20031 CHAPEL POINT LN

INSTALLATION, CONSTRUCTION, ALTERATION, AND/OR REPAIR PERMIT

APPLICATION FOR AN IMPROVEMENT PERMIT

IMPROVEMENT PERMIT

PLOT OF SYSTEM

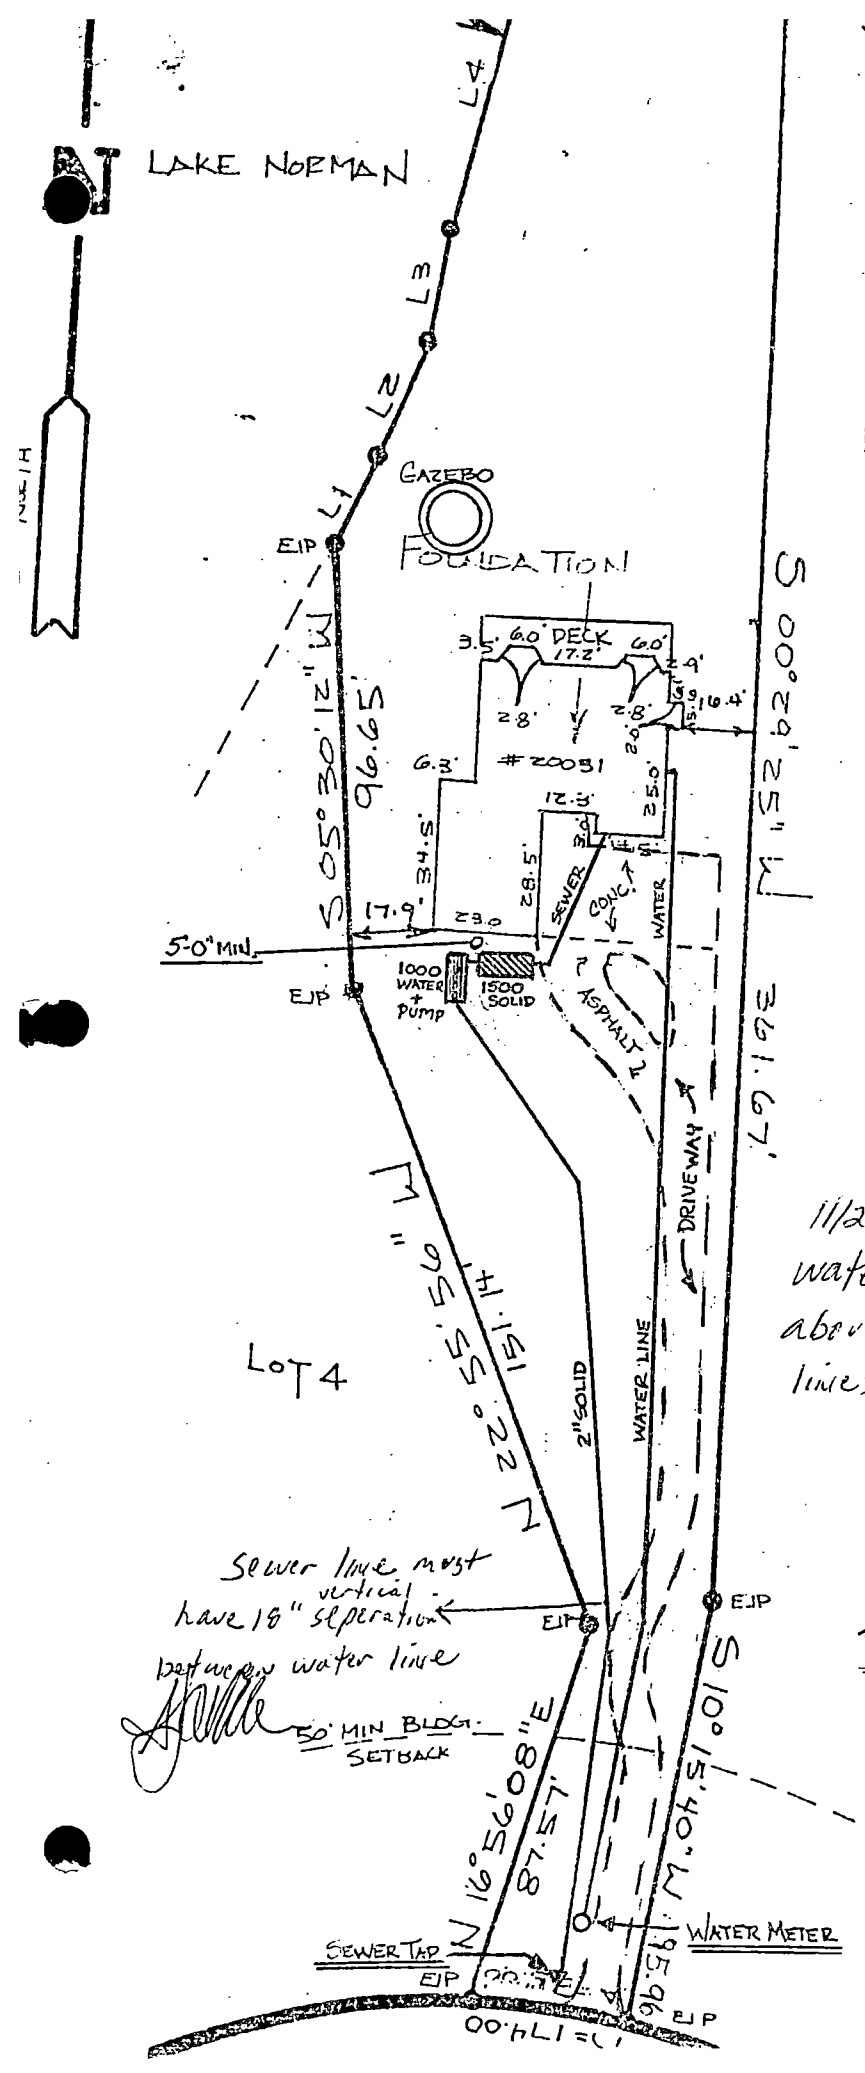
Comments: Water line must have at least 18" vertical separation above sewer line in areas where the lines are closer than 10'

Water line must have at least 18" seperation above sewer line in areas where the lines are closer than 10".

Sewer line must have 18" vertical seperation between water line

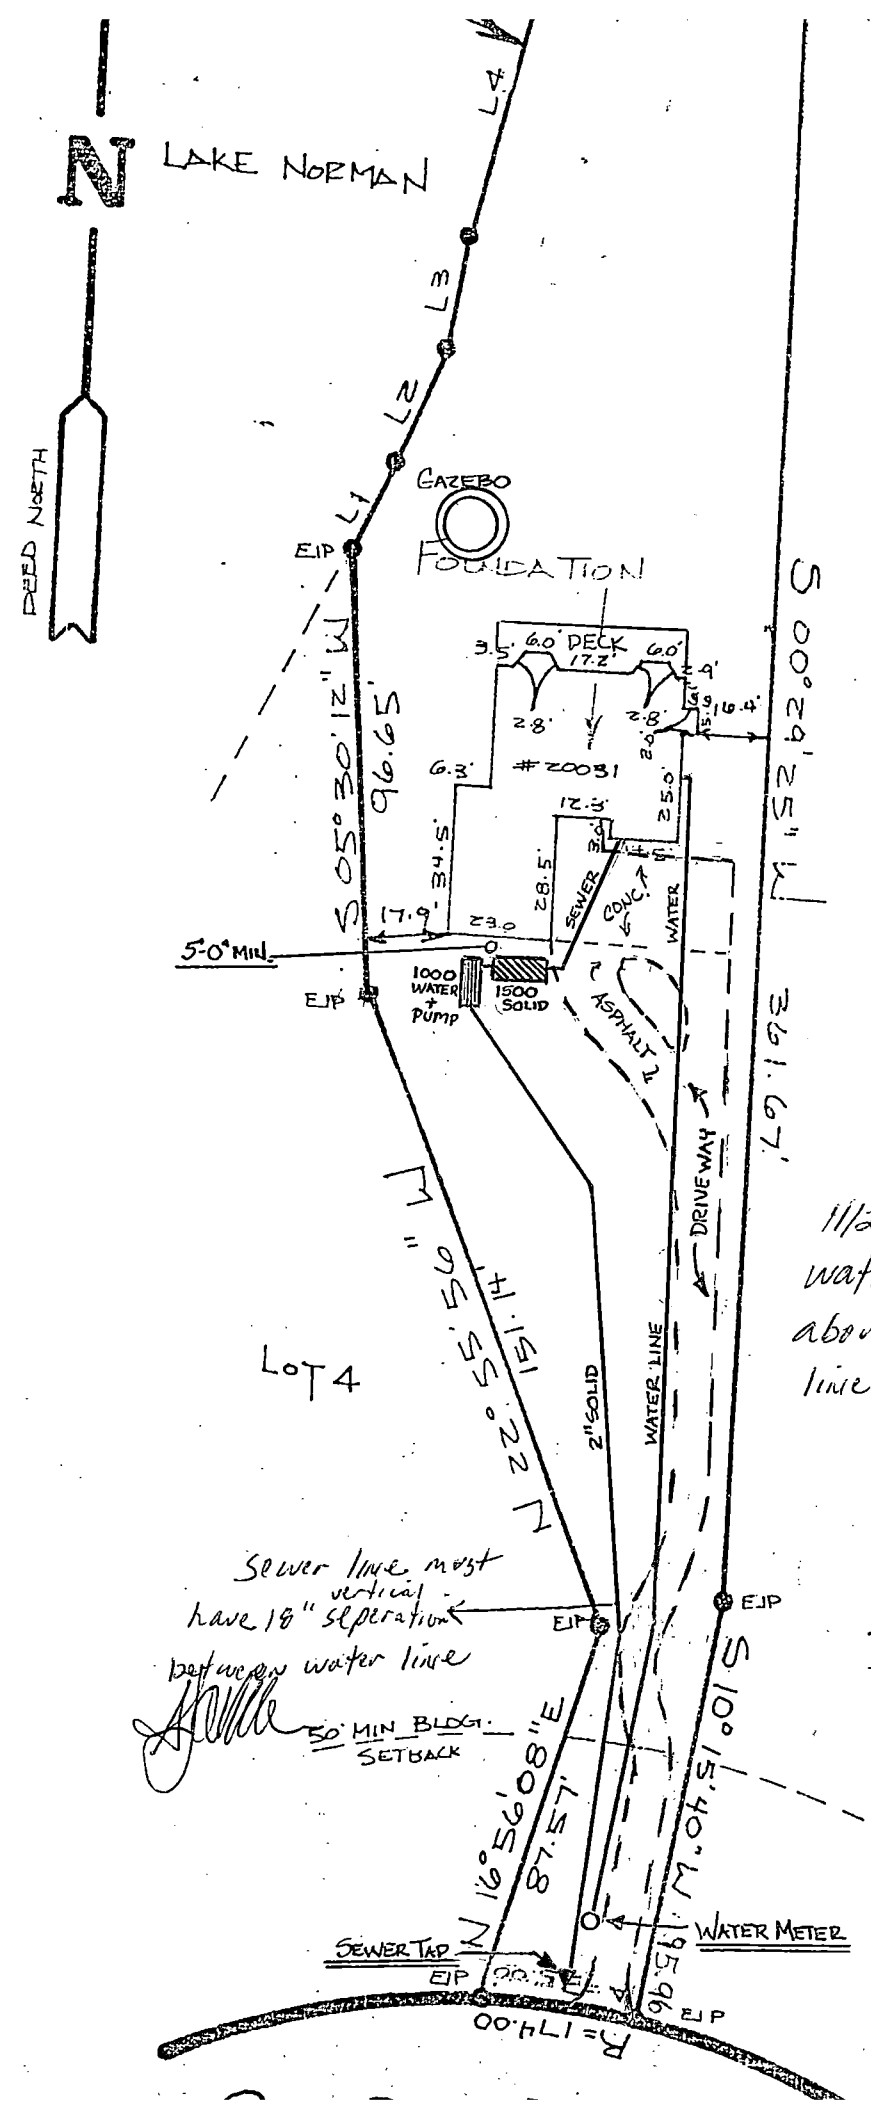
11/22/89
water line must have at least 18" seperation above sewer line in areas where the lines are closer than 18".

Sewer line must have 18" vertical seperation between water line
